## Technical Review

**Client:** Cranbrook Basements Ltd.  
26-28 Hammersmith Grove,  
London,  
W8 7BA

**Project:** Review of Eight Associates Technical Report on  
lifetime carbon analysis of basement extensions for  
London Borough of Kensington & Chelsea

**Date:** 21/08/2013

DRAWING TITLE:  
**PROPOSED GROUND**  
**FLOOR PLAN**

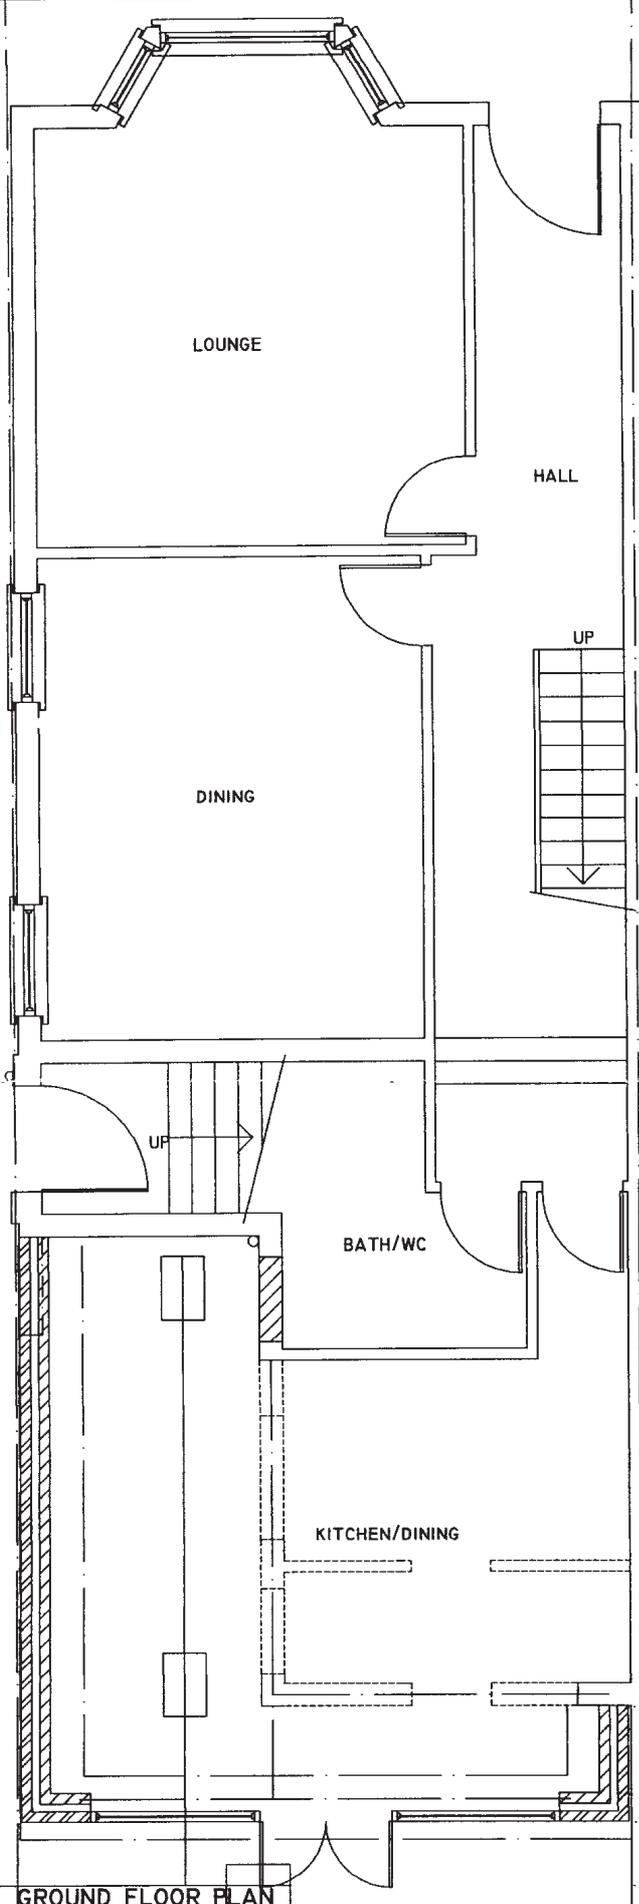
The wall height is quoted as being 2m. This affects the calculations for embodied carbon associated for the brick work, block work and insulation. Drawing No. 06 submitted with the planning application (PP/10/279/A) clearly shows the wall height as 2.6m. This increases the embodied carbon associated with these materials from 1821.21kgCO<sub>2</sub> to 2341.49kgCO<sub>2</sub>, an increase of 520.28kgCO<sub>2</sub>.

Drawing Nos. 01 and 06 (Appendix 1) also clearly show three structural steel beams will be required with a combined length of 12.67m. If

The embodied carbon calculations do not include for the below ground footings. Drawing No. 06 shows a foundation including a brick work wall of 0.425m in height and a concrete footing of 0.65mx0.7m. This amounts to an additional 2,925.11kgCO<sub>2</sub> of embodied carbon.
